**PSEG** Public Service  
Electric and Gas  
Company

April 24, 1984

NRC REVIEW OF STRUCTURAL/GEOTECHNICAL TOPICS  
HOPE CREEK GENERATING STATION  
DOCKET NO. 50-354

Attachment: Resolution of NRC Comments on  
Structural/Geotechnical Topics

FIGURE - 2

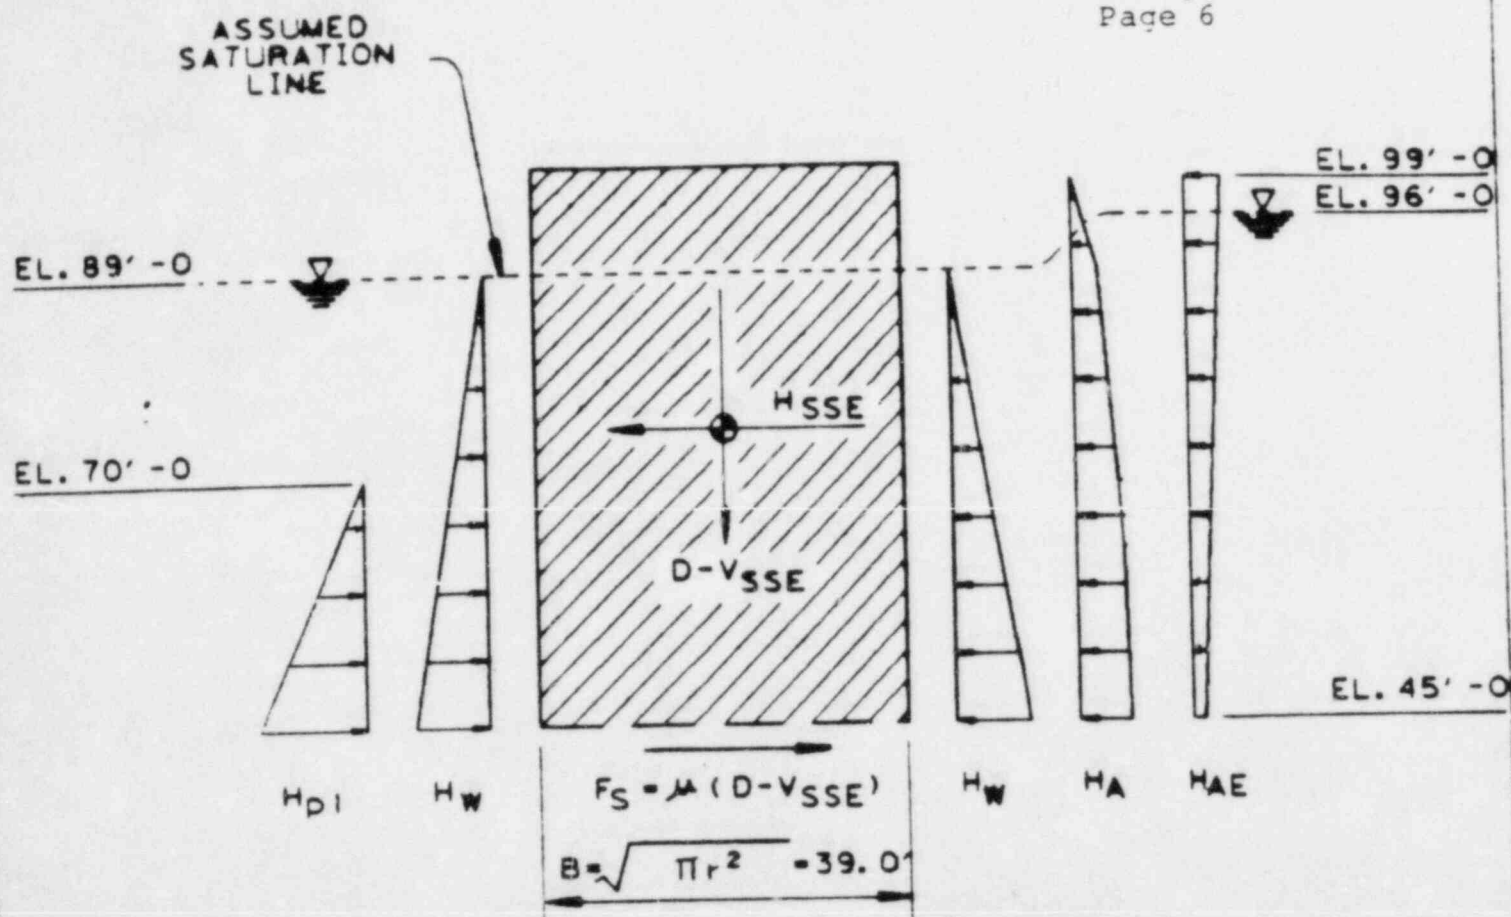
QUESTION: The response to FSAR question 241.29 should include information on gantry crane piles (including pile tip elevations) and cofferdam configuration adjacent to intake structure. Provide design summary for Cofferdam stability during seismic events without considering liquefaction of soils.

Load combinations, key assumptions, and summary of safety factors for the cofferdam stability analyses are presented. Figures 1 and 2 show the cofferdam and surrounding area.
